[Conversion Calculator](#)**2000 Mazda Protege LX L4-1.6L DOHC**[Vehicle Level](#) → [Technical Service Bulletins](#) → [All Technical Service Bulletins](#) → [Engine Controls - MIL ON/Driveability Concerns](#) ←**Engine Controls - MIL ON/Driveability Concerns**

Bulletin No: 01-018/01

Subject:

MIL ILLUMINATION WITH P0171, P1170, LACK OF POWER, HESITATION

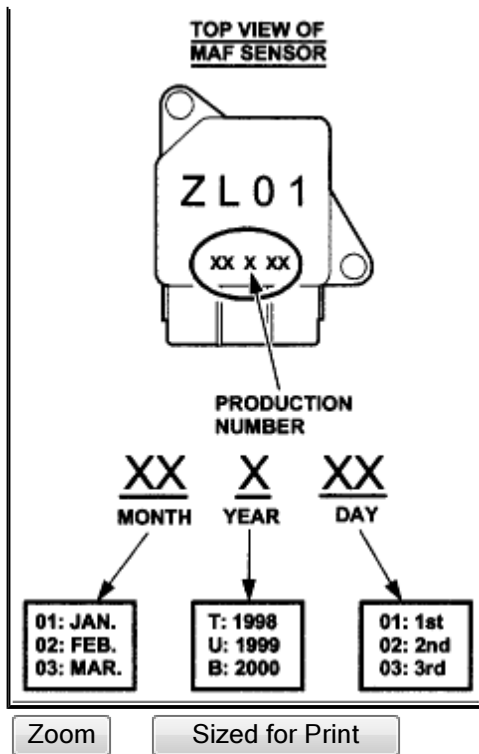
Some vehicles may exhibit MIL illumination with any of the following symptoms: DTC P0171, DTC P1170, Lack of power, Hesitation, Unstable idle. These conditions may be caused by contamination of the mass air flow sensor wires.

- If MAF sensor has a production date before 07B27 (July 27, 2000), proceed to STEP 5.
 - If MAF sensor has a production date on or after 07B27 (July 27, 2000), this Service Bulletin does not apply. Refer to Workshop Manual for further diagnostic procedures.
5. Clean surface surrounding MAF sensor.
 6. Replace MAF sensor.

1. Verify customer concern.
2. Record DTC and Freeze Frame data.
3. Inspect intake system for vacuum leaks.
4. Identify production date on MAF sensor.

Note: Make sure O-ring is correctly positioned on replacement MAF sensor before installation.
